Addendum No. 2

Fotteral Square RFP (2400 N. 11th Street)

Philadelphia Redevelopment Authority

**Fotteral Square
Bidder Questions and Answers**

PROJECT NO.	DRAWING NO.
2020-513	E-001

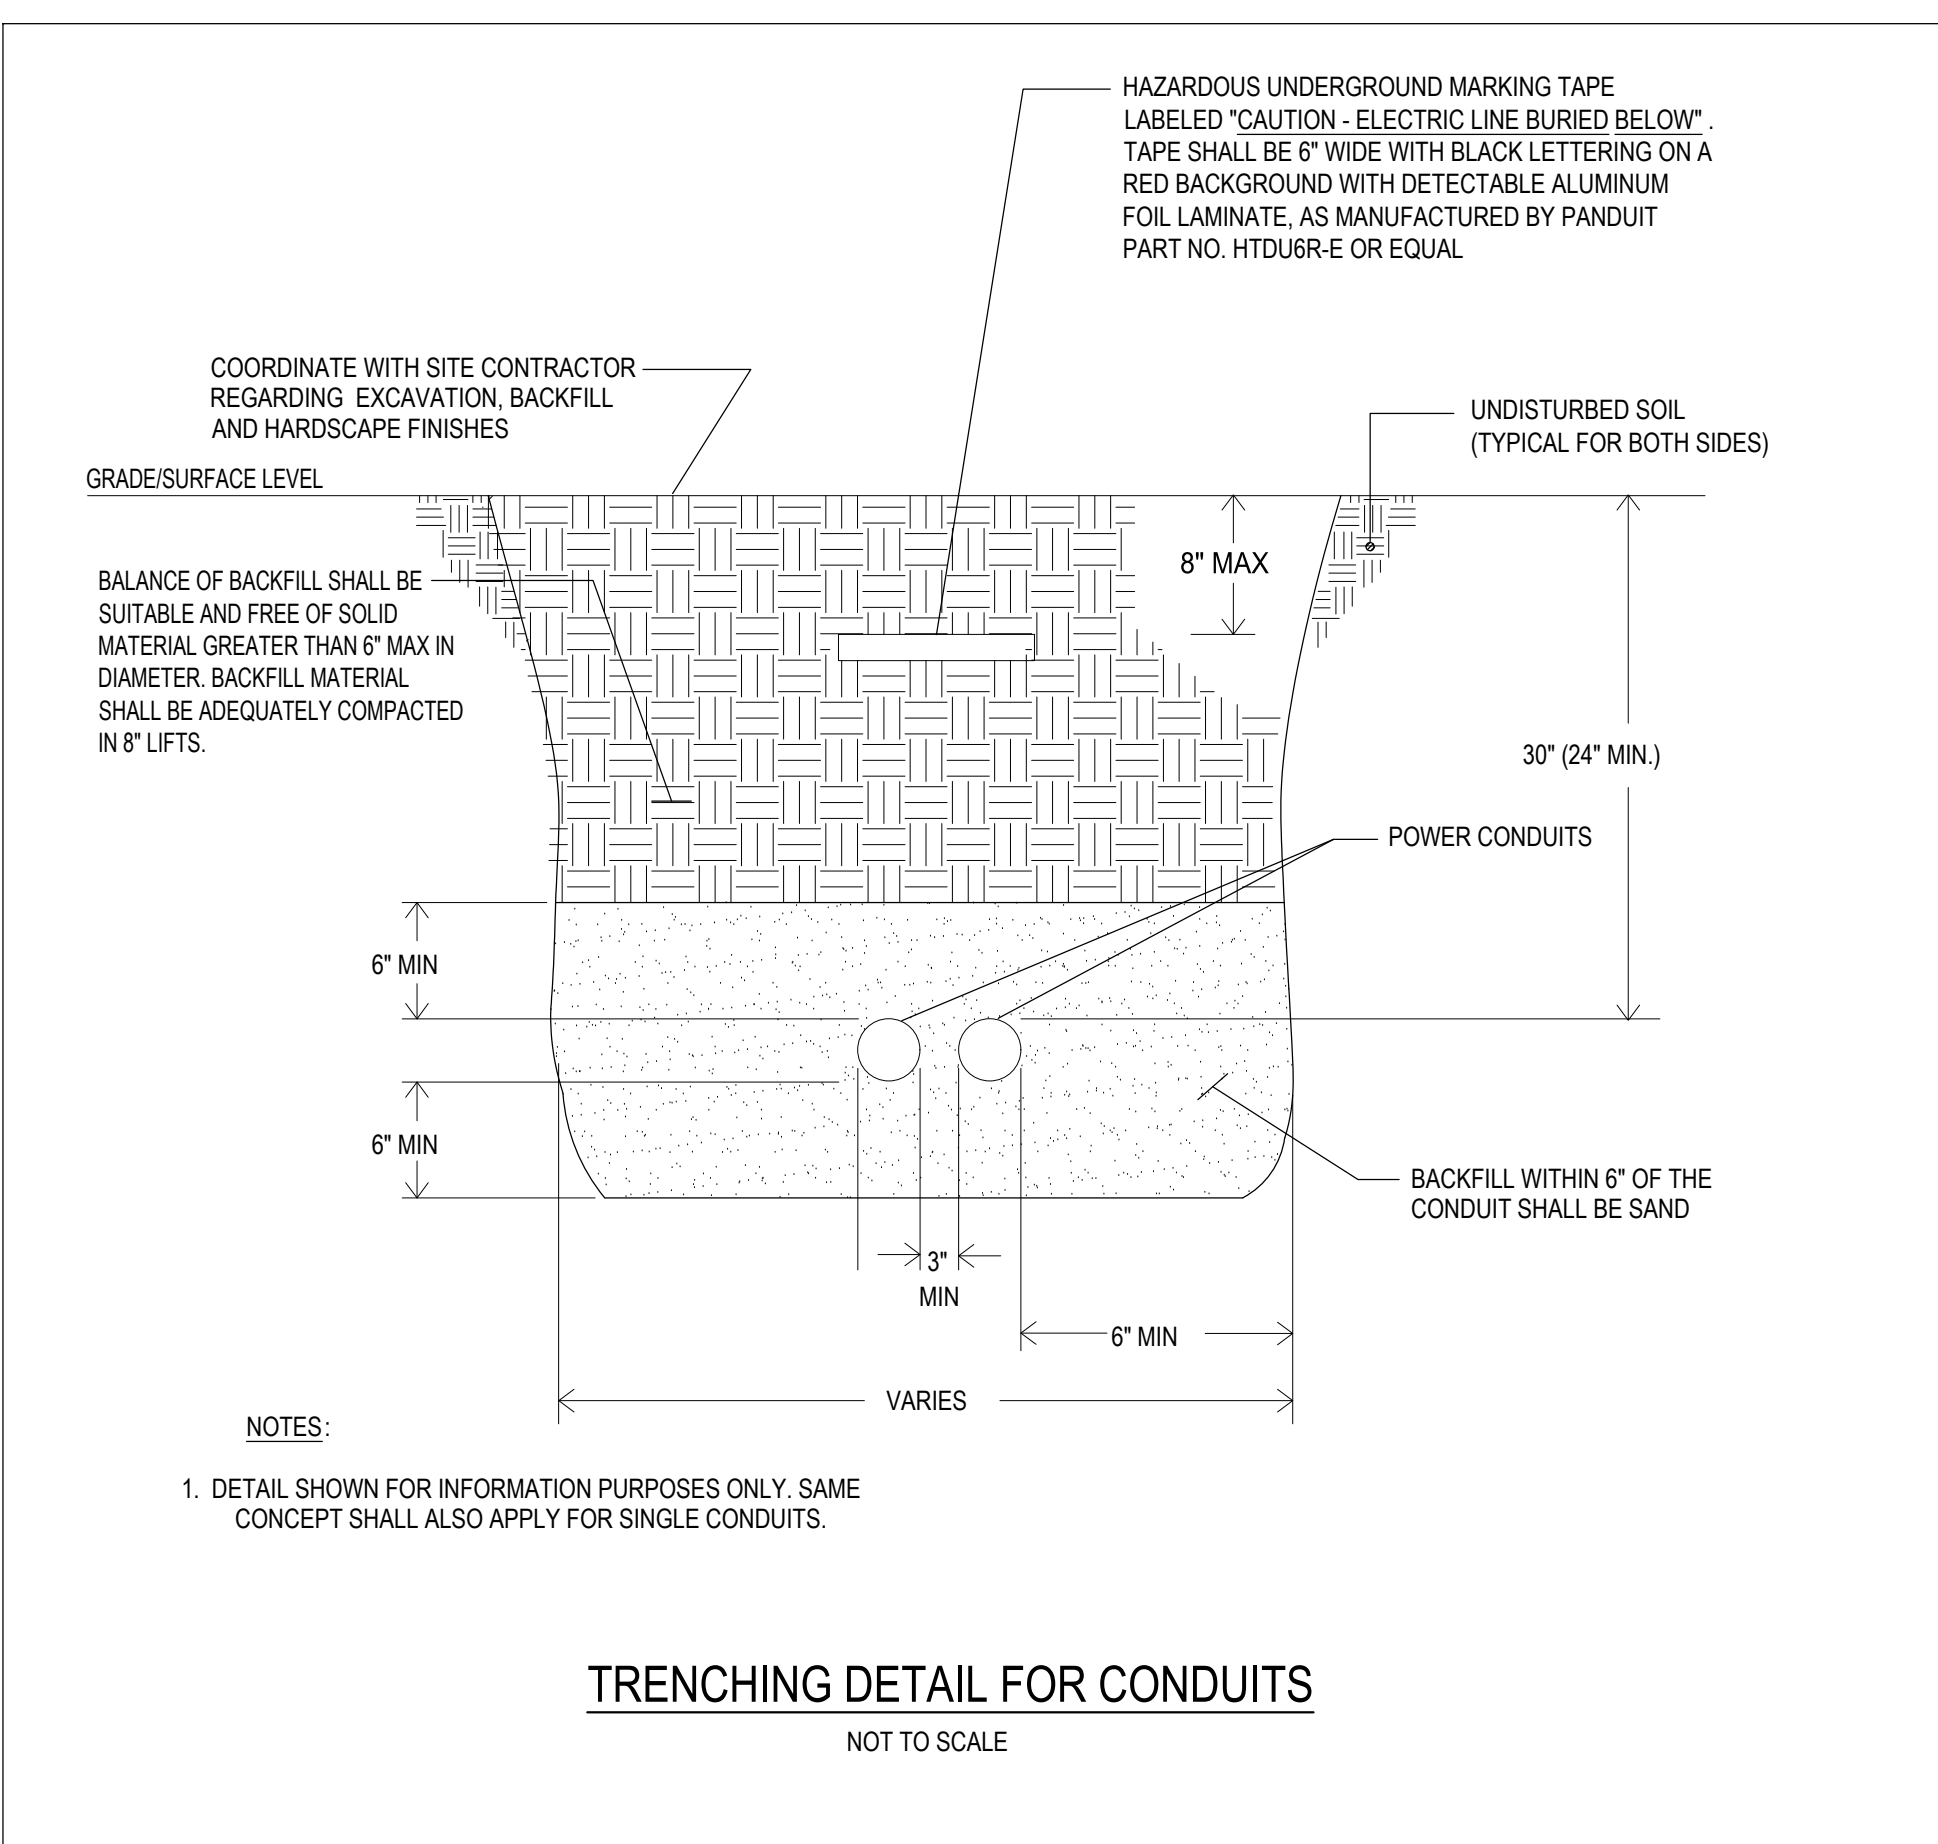
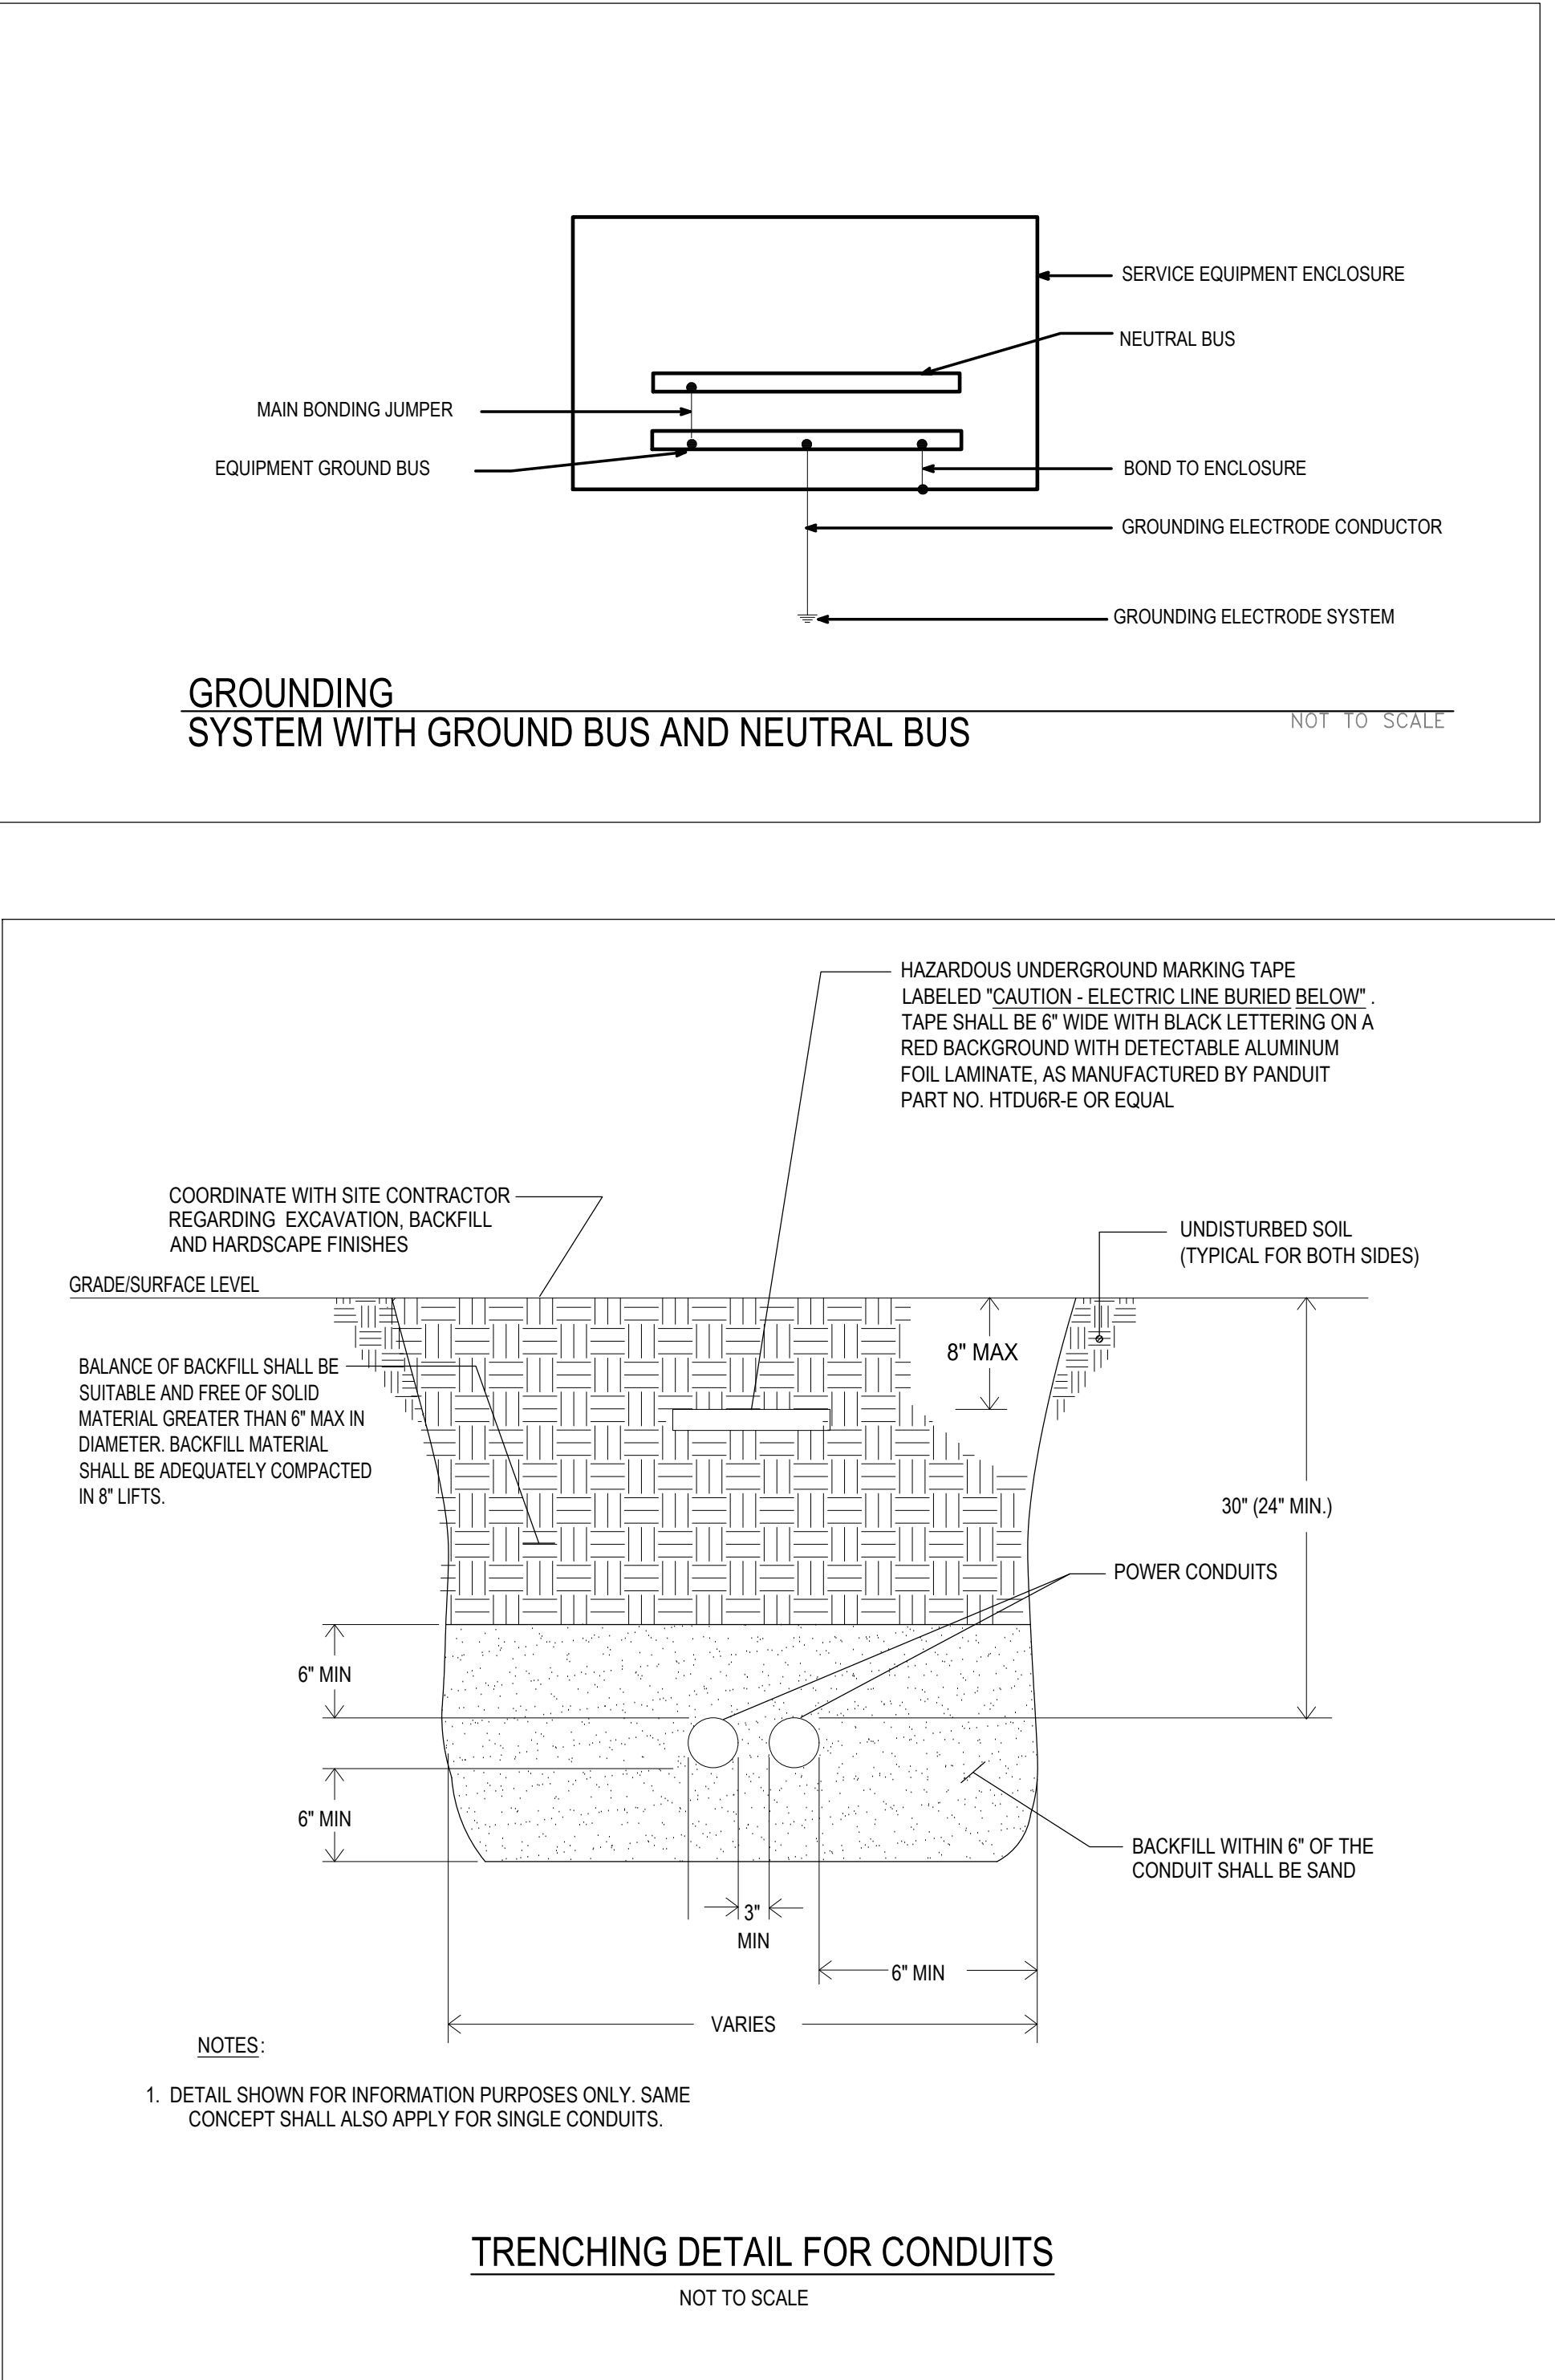
7. Drawing E-001 General Note #30: Please confirm "all underground conduit will be galvanized rigid steel" instead of PVC which is the Recreation Dept. norm. This will add over 20% to the electrical quote in manhours and material.

8. Drawing E-001-Pole and Base Detail: Are two Polymer-Concrete junction boxes required at each pole, one for power and one for cameras? Pole diameter is too small to loop conduits in and out.

Response: Rigid PVC conduit shall be used for all underground raceways in areas not regularly subject to vehicular traffic, for raceways in concrete walls, floors, and ceilings, and for raceways to be run through cinder fill. Provide a separate, code-sized ground wire in each PVC conduit.

Response: A single junction box may be used at each pole if it complies with all codes.

30. ALL UNDERGROUND CONDUIT SHALL BE HOT DIPPED GALVANIZED STEEL WITH WARNING TAPE ABOVE IT. RIGID PVC CONDUIT IS ACCEPTABLE TO USE FOR ALL UNDERGROUND RACEWAYS IN AREAS NOT REGULARLY SUBJECT TO VEHICULAR TRAFFIC. PROVIDE CODE-SIZED GROUND WIRE IN EACH PVC CONDUIT AS PER NEC 250.
